Access Compliance Report Public Rights-of-Way (Curb Ramps)

Intersection ID: N/A Main Street: NATIONS_FORD_RD Cross Street: N/A Location: N

ADA ID: A71E1B37F5FD Ramp Type: PerpDiag Initial Pass/Fail: Fail Overall Compliance: No Severity Score: 12.5

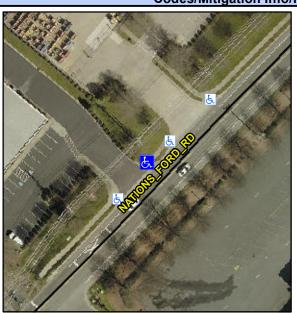
PROW/ADA:
R304.2.2

Compliance Description Data Compliance Description Data No Ramp Slope (%) N/A Ramp Length (in) 48.0 9.5 Yes Ramp XSlope (%) Yes Ramp Width (in) 48.0 0.9 N/A N/A Flare Type LT N/A Flare Type RT N/A N/A N/A N/A Flare Slope RT (%) N/A Flare Slope LT (%) N/A Flare Traversable LT? Nο N/A Flare Traversable RT? No N/A Landing Length (in) N/A N/A DWS Provided? N/A N/A Landing Width (in) N/A N/A **DWS Contrast?** N/A N/A N/A Landing Slope (%) DWS Length (in) N/A Landing X Slope (%) N/A N/A DWS Full Width? N/A Landing Curb? (Y/N) N/A N/A DWS Offset (in) N/A N/A Shared Landing? **Gutter Ponding?** N/A N/A Gutter Slope (%) N/A Gutter Lip Ht (in) N/A N/A Gutter X Slope (%) N/A Painted X Walk1? No N/A Painted X Walk2? No X Walk 1 Direction To SW X Walk 2 Direction To SE N/A N/A X Walk 1 Width (in) X Walk 2 Width (in) X Walk 1 Slope (%) 2.0 X Walk 2 Slope (%) 5.6 X Walk 1 X Slope (%) 3.5 X Walk 2 X Slope (%) 1.2 N/A N/A Ramp inside XWalk2? N/A Ramp inside XWalk1? Road Slope (%) 5.4 N/A Clear Space? N/A N/A Road X Slope (%) 3.4 Clear Space to XWalk (in) N/A N/A N/A Any Obstructions? Storm Grate/Utility Hazard? N/A **Obstruction Type** Storm Grate/Utility Type N/A N/A

Remove & Replace Curb Ramp With
Two New Directional Ramps or
Equivalent.
